Access Compliance Report

Public Rights-of-Way

(Curb Ramps)

Intersection ID: 15270	Main Street: GRIFFITH_ST	Cross Street: NEW_BERN_ST	Location: SE
ADA ID: BBA50FF573B6	Ramp Type: Perp	Initial Pass/Fail: Fail	Overall Compliance: No
Severity Score: 13.75			
Codes/Mitigation Info/Possible Solution		Field Measurements/Component Compliance

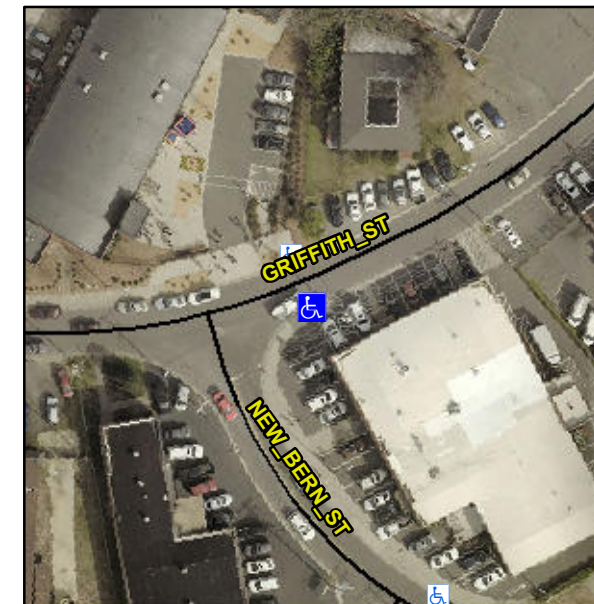
Not Found, R304.2.2, R304.5.3

Compliance	Description	Data	Compliance	Description	Data
N/A	Ramp Length (in)	70.0	No	Ramp Slope (%)	10.0
Yes	Ramp Width (in)	48.0	No	Ramp XSlope (%)	2.5
N/A	Flare Type LT	N/A	N/A	Flare Type RT	N/A
N/A	Flare Slope LT (%)	N/A	N/A	Flare Slope RT (%)	N/A
N/A	Flare Traversable LT?	N/A	N/A	Flare Traversable RT?	N/A
N/A	Landing Length (in)	N/A	N/A	DWS Provided?	N/A
N/A	Landing Width (in)	N/A	N/A	DWS Contrast?	N/A
N/A	Landing Slope (%)	N/A	N/A	DWS Length (in)	N/A
N/A	Landing X Slope (%)	N/A	N/A	DWS Full Width?	N/A
N/A	Landing Curb? (Y/N)	N/A	N/A	DWS Offset (in)	N/A
N/A	Shared Landing?	N/A			
N/A	Gutter Ponding?	N/A	N/A	Gutter Slope (%)	N/A
N/A	Gutter Lip Ht (in)	N/A	N/A	Gutter X Slope (%)	N/A
N/A	Painted X Walk1?	No	N/A	Painted X Walk2?	N/A
	X Walk 1 Direction	To NW		X Walk 2 Direction	N/A
N/A	X Walk 1 Width (in)	N/A	N/A	X Walk 2 Width (in)	N/A
	X Walk 1 Slope (%)	2.3		X Walk 2 Slope (%)	N/A
	X Walk 1 X Slope (%)	2.4		X Walk 2 X Slope (%)	N/A

Remove & Replace Entire Ramp.
